Remarks/Arguments

The present Amendment is made in response to the Office Action dated November 1, 2005, and identified as Paper No. 10192005. Claims 1-12 remain pending in the application.

Reply to Office Action dated November 1, 2005
Application Serial No. 10/677,528
Amendment dated February 1, 2006

FIG.1

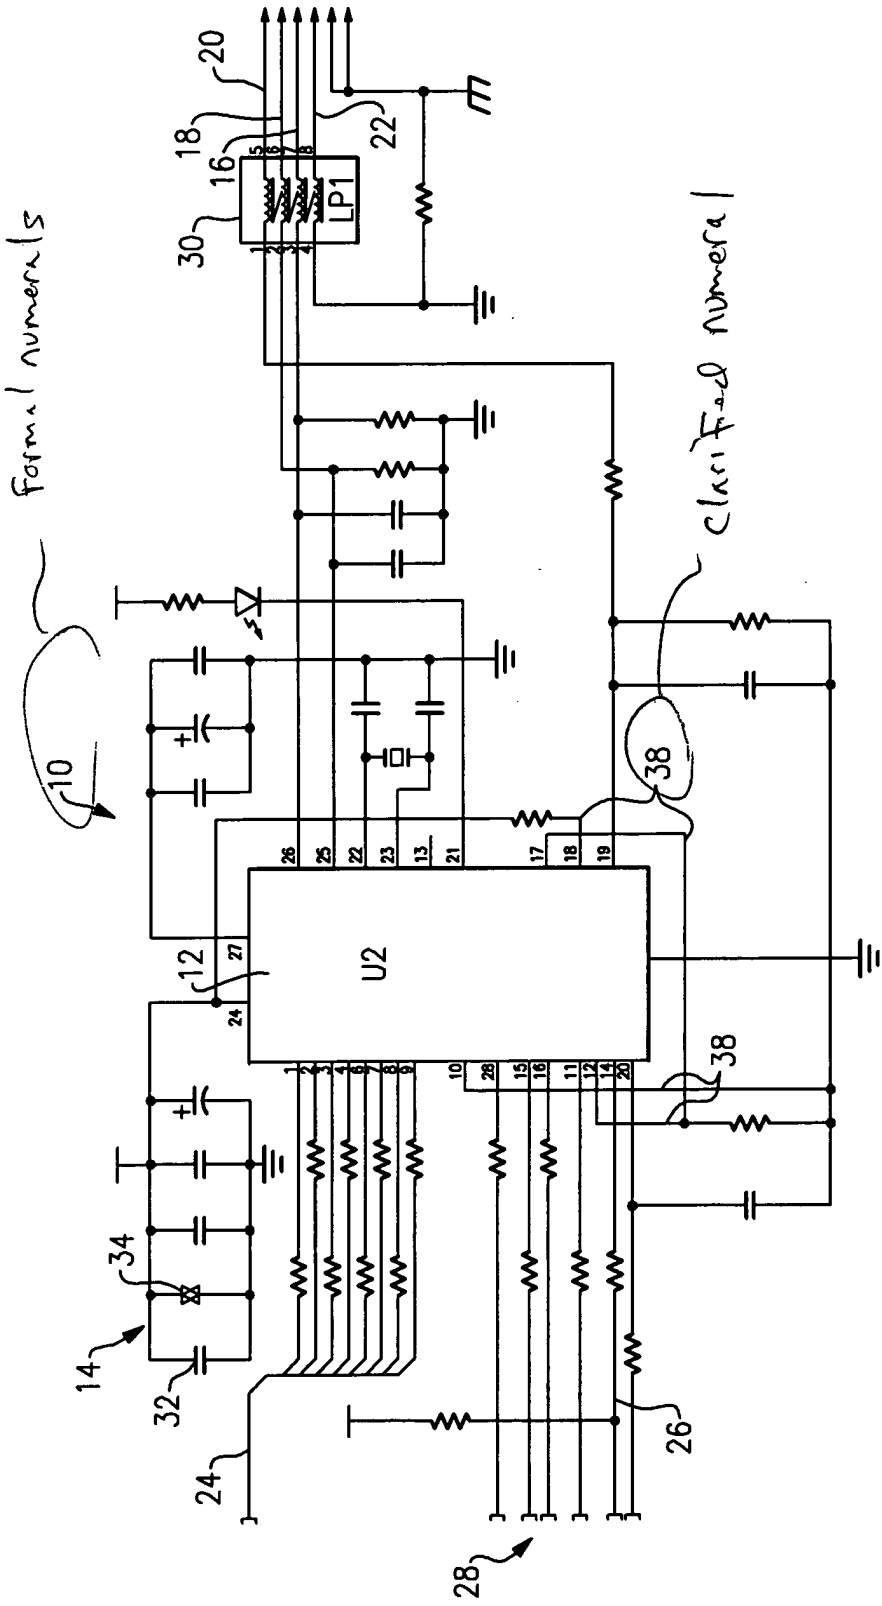
In the Action, the Examiner objected to the drawings because a reference numeral was unclear and not mentioned in the specification. The Examiner objected to claim 1 as including an acronym. The Examiner rejected claims 1-3, 5-6, 8-10, and 12 as unpatentable under 35 U.S.C. § 103 as obvious over U.S. Patent No. 6,937,454 to Mikolajczak et al. ("*Mikolajczak*") in view of U.S. Patent No. 6,101,076 to Tsai et al. ("*Tsai*"). Claims 4 and 11 were rejected as unpatentable under 35 U.S.C. § 103 as obvious over *Mikolajczak* and *Tsai* in further view of U.S. Patent No. 4,571,656 to Ruckman ("*Ruckman*"). Claim 7 was rejected as unpatentable under 35 U.S.C. § 103 as obvious over *Mikolajczak* and *Tsai* in further view of U.S. Patent No. 6,452,269 to Ohbayashi ("*Ohbayashi*") and U.S. Patent No. 5,956,158 to Pinzarrone et al. ("*Pinzarrone*").

Applicant has submitted amended drawings complying with the Examiner's request for formal drawings. Applicant has also amended the specification to correct a typographical error in the reference to numeral 38 of Fig. 1.

The attached sheets of drawings includes changes to Fig. 1 and 2. These sheets, which include Figs. 1 and 2, replace the original sheets including Figs. 1 and 2. The drawing figures have been amended to clearly show the reference numeral at the bottom of Fig. 1 and comply with regulations regarding formal drawings.
